LR-N07-0222

SALEM GENERATING STATION – UNIT 1 and UNIT 2  
FACILITY OPERATING LICENSE NOS. DPR 70 and DPR-75  
NRC DOCKET NOS. 50-272 and 50-311

**Subject: RESPONSE TO RAI #3 ON LCR S06-10 (TAC Nos. MD4843 & 4844)  
STEAM GENERATOR FEEDWATER PUMP TRIP, FEEDWATER ISOLATION  
VALVE RESPONSE TIME TESTING and CONTAINMENT COOLING  
SYSTEM**

REQUEST FOR ADDITIONAL INFORMATION #3  
REGARDING PROPOSED LICENSE AMENDMENT  
STEAM GENERATOR FEEDWATER PUMP TRIP,  
FEEDWATER ISOLATION VALVE CLOSURE RESPONSE TIMES,  
AND CONTAINMENT FAN COIL UNIT COOLING WATER FLOW RATE  
SALEM NUCLEAR GENERATING STATION, UNIT NOS. 1 AND 2  
DOCKET NOS. 50-272 AND 50-311

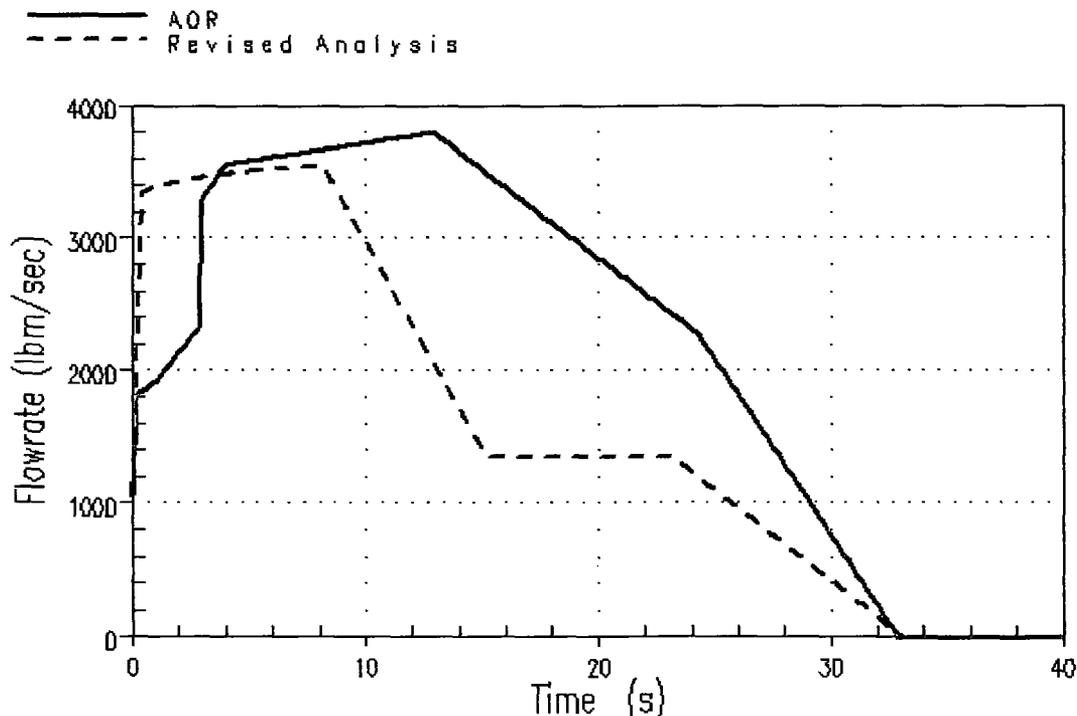
SCVB-1: It was stated in several places of the license change request that the AOR for the single failure scenario of the faulted loop feedwater regulating valve (FRV) failing open is overly conservative as it assumed full feedwater (FW) flow to the faulted steam generator (SG) for 32 seconds, until the FIV is fully shut. The revised modeling with WCAP-16503 credits reduced flow when the SGFP is tripped. It further reduces the flow as FIV closure increasingly throttles the flow from the condensate pumps. In addition, the revised modeling assumes that during the SGFP coastdown, FW flow will decrease linearly to the flowrate provided by the condensate pumps through freewheeling SGFPs. The revised modeling has broken down the 32 second closing time of the FIV and the 14 second time for the SGFP to come to a stop from freewheeling as follows:

FIV: Two-second electronic time delay before initiation of the valve closure, 20-seconds of valve closure that have no impact on the FW flowrate, and a linear flowrate reduction during the final 10-seconds of the valve stroke.

SGFP: Seven seconds for tripping of the SGFPs (instrument and mechanical delays), and seven seconds for coast down.

- a) How does the FW flow to the faulted SG differ between the AOR and the revised model?

- b) Provide, in quantitative terms, flow considered in the AOR for the entire 32 seconds FIV closure and a breakdown of flow in the revised model during the seven seconds of the SGFP trip, seven seconds of SGFP coast down, the time remaining (eight seconds) prior to the linear flowrate reduction, and the final 10 seconds of the FIV stroke during which flowrate is reduced linearly.

The AOR does not assume full feedwater flow to the faulted SG for 32 seconds. The overly conservative assumption of the AOR was that the trip of the main feedwater (MFW) pumps was not considered. However, the AOR had complex assumptions associated with the effect of valves. It assumed 1) a ramp opening of the feedwater control valve (FCV) on the faulted loop at the beginning of the event lasting until 3 seconds after the SI setpoint is reached, 2) the sudden closure of the intact loops' FCVs at 2 seconds after the SI setpoint is reached, and 3) a decrease in the MFW flowrate due to the closure of the feedwater isolation valve (FIV) over the last 20 seconds of the 30-second stroke time of the FIV. These assumptions have been in the AOR since at least the 1993 Fuel Upgrade / Margin Recovery Project.

The MFW flow to the faulted SG in the latest Salem analysis has credited the benefit of the MFW pump trip, but is based on more conservative assumptions (i.e., more limiting for the analysis) than the AOR relative to the modeling of valve positions and their effect on the MFW flowrate. The revised analysis conservatively assumes that the FCV on the faulted loop immediately fully opens in response to the steamline break, while the FCVs on the intact loops are assumed to immediately close. The revised analysis also credits a flow reduction due to the closure of the FIV during only the last 10 seconds of the 30-second stroke time.

This discussion pertains to the SLB cases with a single failure of the FCV (failed open) on the faulted loop. It also only addresses the addition of MFW due to pumped flow; there is additional MFW added to the faulted SG due to flashing of the water in the unisolable feedline volume between the SG and the FIV, after the FIV closes. The plot below shows a comparison of the pumped MFW flowrate delivered to the faulted SG for the AOR compared to the revised analysis, using an example of a 1.4 ft<sup>2</sup> double-ended rupture SLB on Unit 2 initiated from full power.

The integrated pumped MFW flow delivered to the faulted SG in the AOR is approximately 87,000 lbm.

In the revised analysis the integrated MFW flow is:

- 27,700 lbm at 8.1 seconds, when the MFW pump coastdown starts,
- 45,100 lbm at 15.1 seconds when the flow coastdown of the MFW pump stops,
- 55,900 lbm at 23.1 seconds when the reduction due to the FIV closure starts,
- 62,900 lbm when the FIV is fully closed at 33.1 seconds.

SGFP Coastdown Assumption Sensitivity

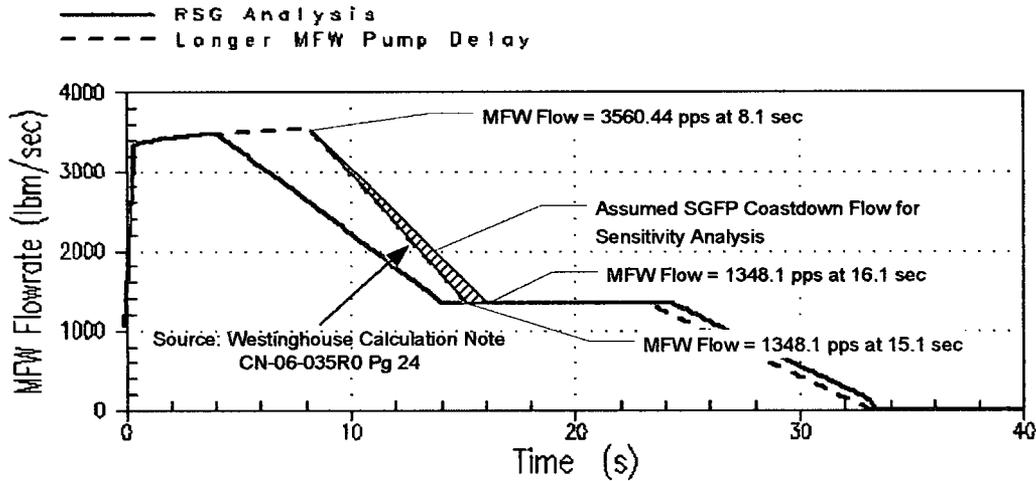
- c) What is the sensitivity of the Salem analysis if the SGFP takes longer than 7 seconds to coastdown?

The figure below is a markup of a feedwater flow plot from Westinghouse CN-CRA-06-035 which shows the sensitivity of the feedwater flow to the pump coastdown time. In the plot, the SGFP trip occurs at 8.1 seconds into the transient. The Main Feedwater (MFW) flow decreases from a peak of 3560.4 lb/sec (pps) to 1348.1 lb/sec following pump coastdown. Neglecting the change in SG pressure over the interval of the increased SGFP coastdown (15.1 to 16.1 seconds) time will have minimal impact. The integrated MFW mass will increase by approximately 1100 lbm using the integrated hatched area from the plot below. The sensitivity of the containment peak pressure to a change in integrated mass flow is approximately  $1.52E-4$  psig/lbm based on an extrapolation of the CN-CRA-06-035 calculated containment peak pressures and integrated feedwater mass. The result is that the 1 second increase in the SGFP coastdown time would increase the integrated MFW mass by approximately 1100 lbm and would increase the containment peak pressure by 0.17 psig. The Unit 2 containment peak pressure for this scenario would be approximately 44.27 psig, which is less than the containment design pressure of 47.0 psig and would be acceptable.

For comparison, the limiting Unit 2 RSG case is a 1.4 ft<sup>2</sup> Double Ended Rupture (DER) at 30% Power with a containment safeguards train failure and has a peak containment pressure of 45.6 psig. The change in SGFP coastdown characteristics only affects those containment analysis transients that assume a feedwater regulating valve failure.

Therefore, an increase in the coastdown from 7 seconds to 8 seconds has a minimal impact on the integrated mass flow and containment peak pressure.
